RE: **St Joseph on the Rio Grande Church**
5901 St Joseph Dr NW
Conceptual Grading and Drainage Plan
Engineer's Stamp Date: 5/14/18
Hydrology File: G11D014A

Based on the information provided in your submittal received on 5/22/18, the Conceptual Grading and Drainage Plan is not approved for Site Plan for Building Permit.

Re: G11D014A - Church of St. Joseph on the Rio Grande – Conceptual Grading and Drainage Plan

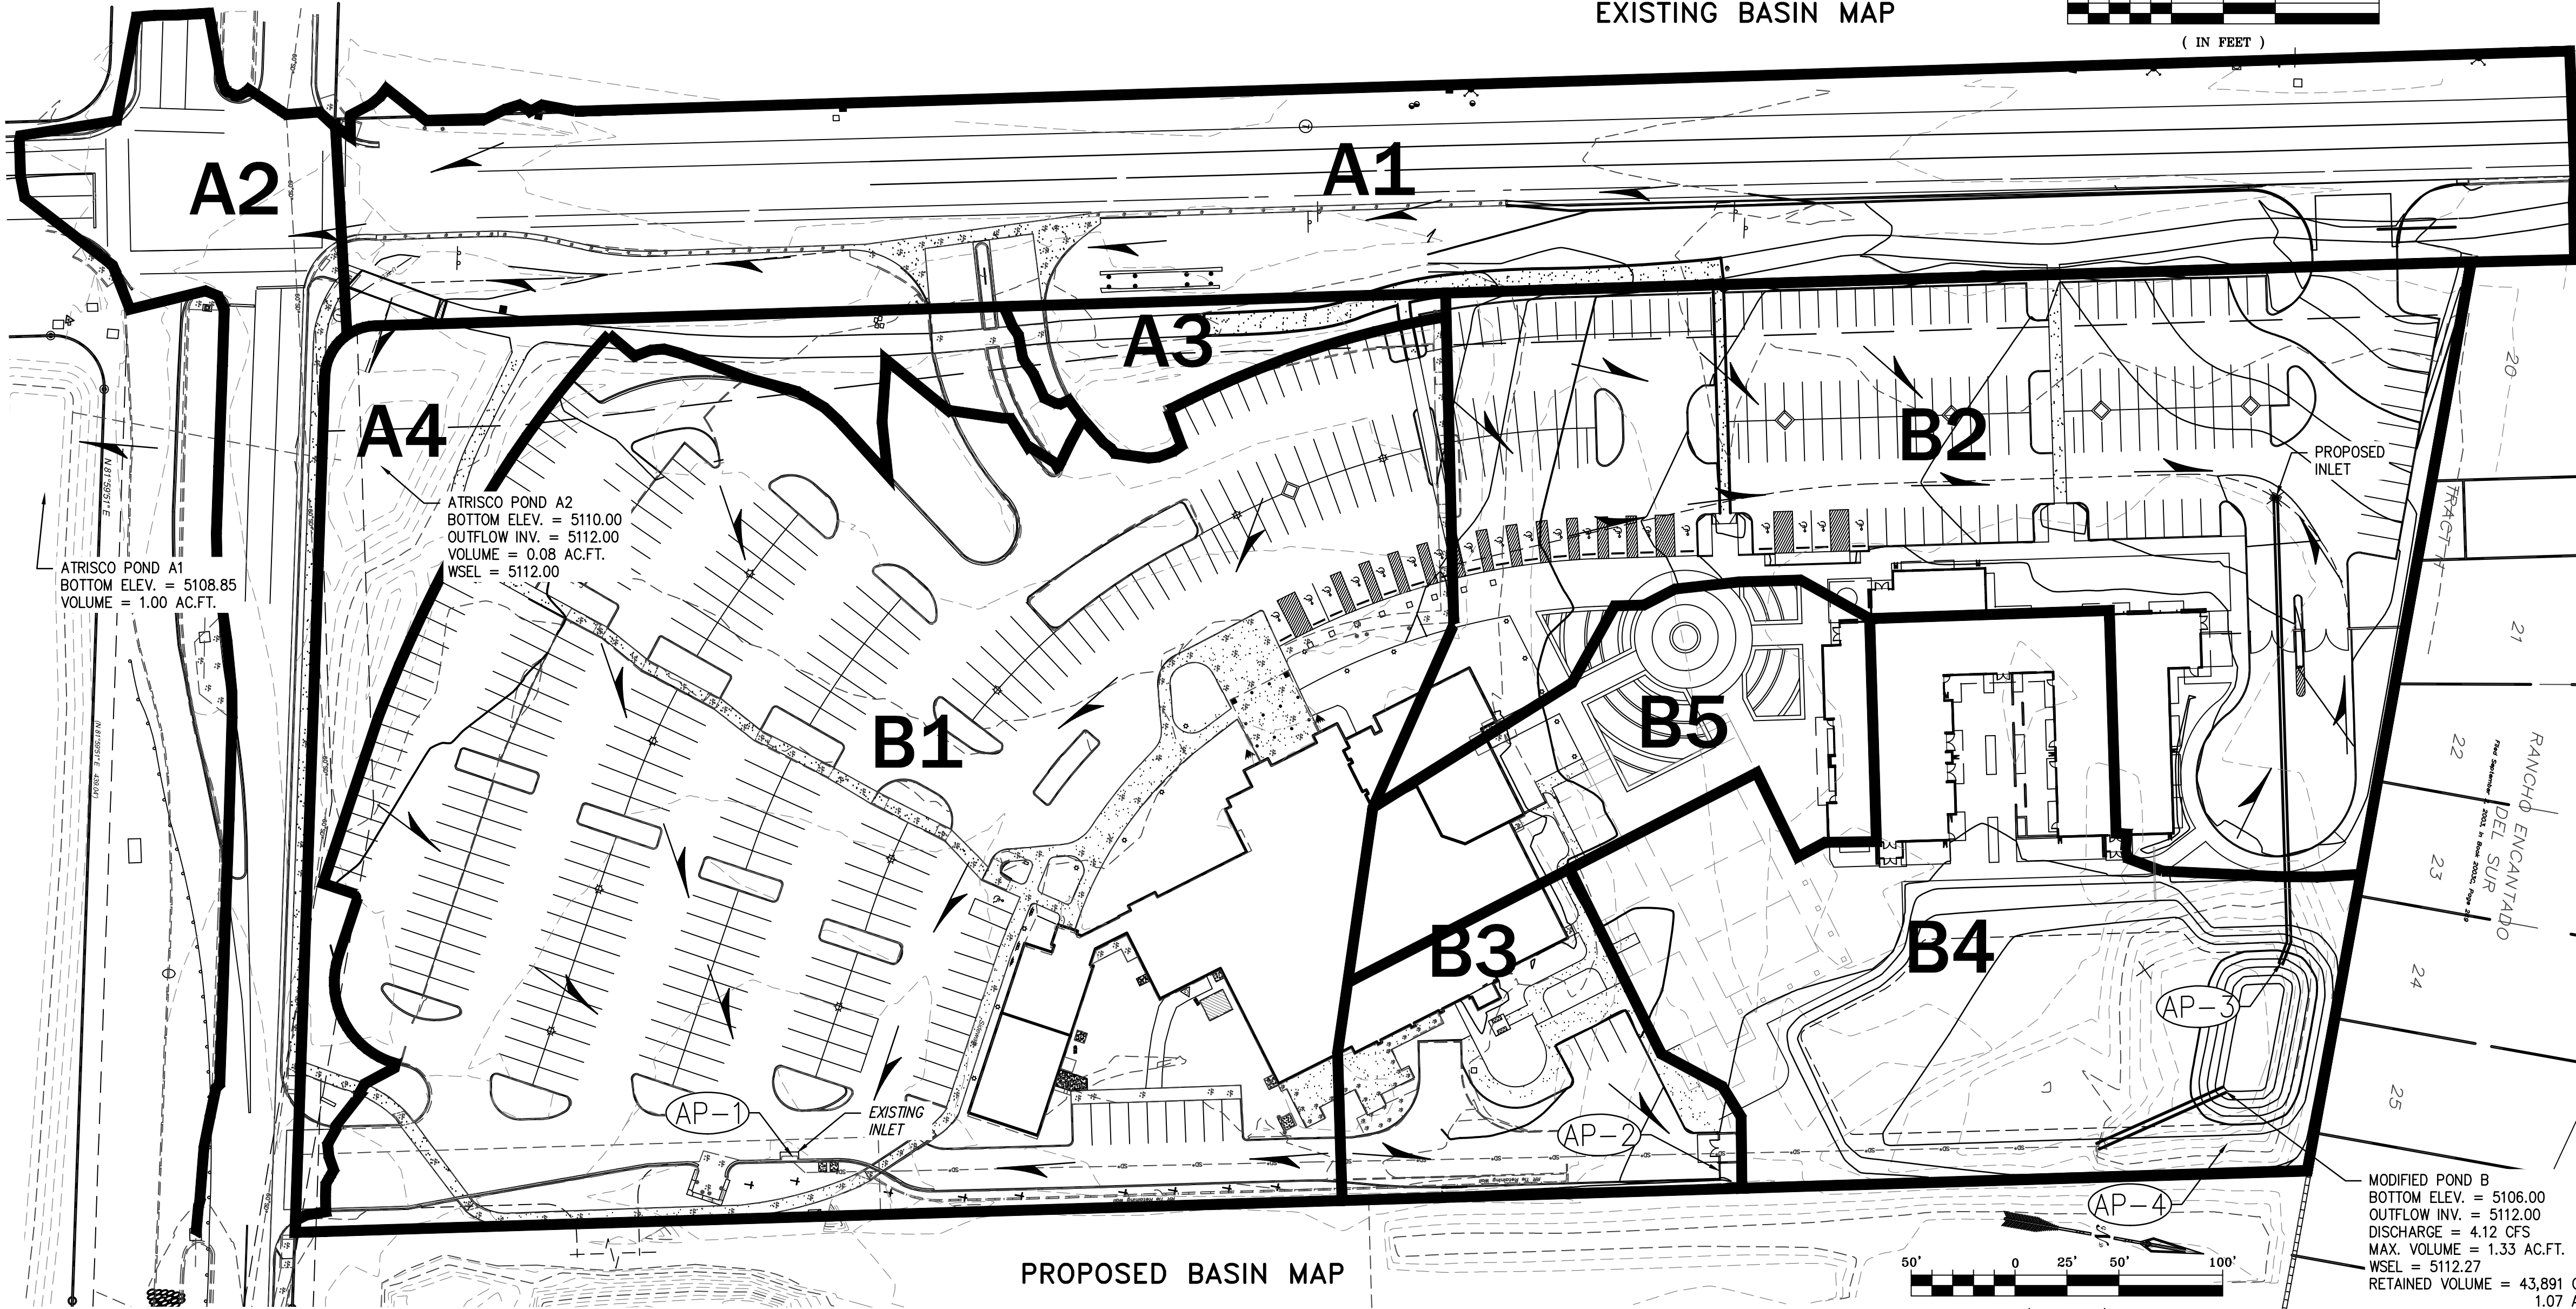
1. Use sidewalk culverts, not a dip section, to convey flows from the Atrisco ROW across the bike path/sidewalk. Size for the 100-yr runoff and include calculations.

1. Address runoff from the Atrisco ROW.

ROW grading is shown to accommodate the ROW drainage to the existing pond. In addition, a drainage covenant has been executed for the pond.
